Percolation Test Report; 3125, West Ivory Road, West Friendship, MD

From: Oswald, Hank
Sent: Thursday, April 29, 2021 9:32 AM
To: Kristy Pierce
Cc: Mike Tran; George Bott, AIA, LEED AP
Subject: RE: 3125 West Ivory Road
Attachments: [Untitled].pdf

From: Oswald, Hank
Sent: Monday, July 12, 2021 10:16 AM
To: Kristy Pierce (kpierce@glwpa.com)
Cc: 'mtran@glwpa.com'
Subject: OSDS Plan_3125 West Ivory Road_Plan Review Comments

Attachment: Percolation Test Field Notes

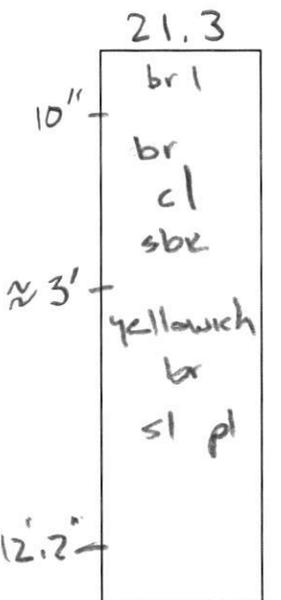
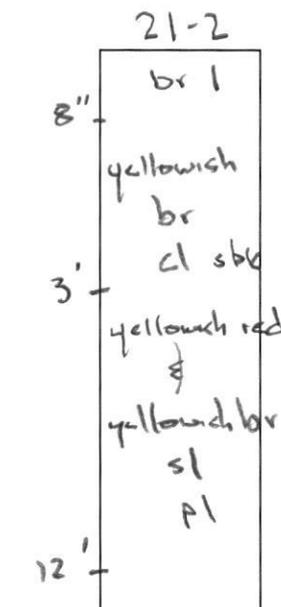
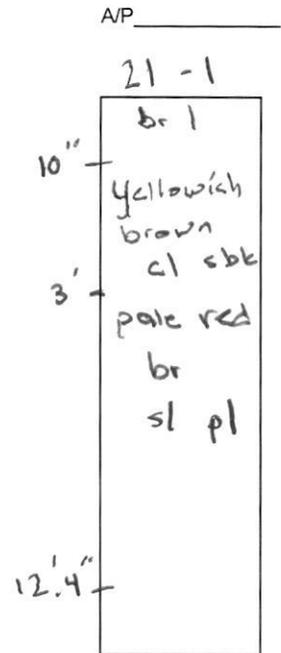
Percolation tests were conducted at 3125, West Ivory Road (Tax Map 15, Parcel 23) on March 23, 2021. Tests and profile descriptions were documented for 4 locations. All 4 test holes passed.
